Hearing Date:	**November 5, 2009**
Property Location	**1463 Kings Down Circle (LL 351)**
Owner/Petitioner	**William and Kelly Blake** **1463 Kings Down Circle** **Dunwoody, Georgia 30338**
Variance Request	**Increase the allowable height of an already-constructed front yard fence in a single-family residential neighborhood from four (4) feet to six (6) feet**

ZBA 09 102

Variance Application

1463 KINGS DOWN CIRCLE
DUNWODY, GEORGIA

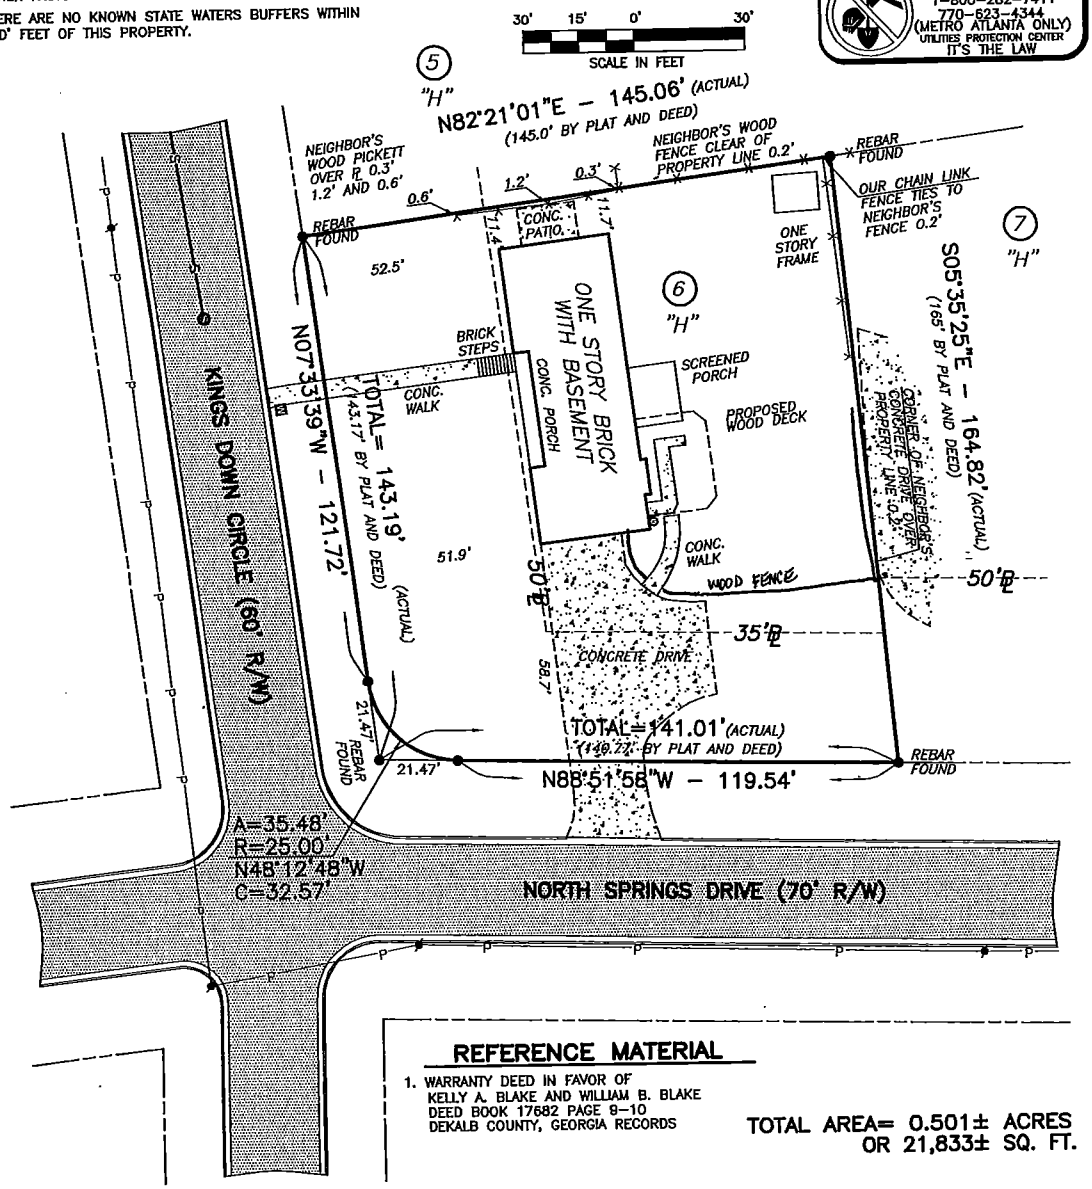
The applicant's lot has 121+/- feet of frontage along Kings Down Circle, and 119+/- feet of frontage along North Springs Drive. The fence in question extends beyond the building façade on the southern side of the house, the side facing North Springs Drive. According to the Dunwoody zoning ordinance, this southern exposure of the home faces the lot's front yard, no matter the architectural orientation of the structure itself.
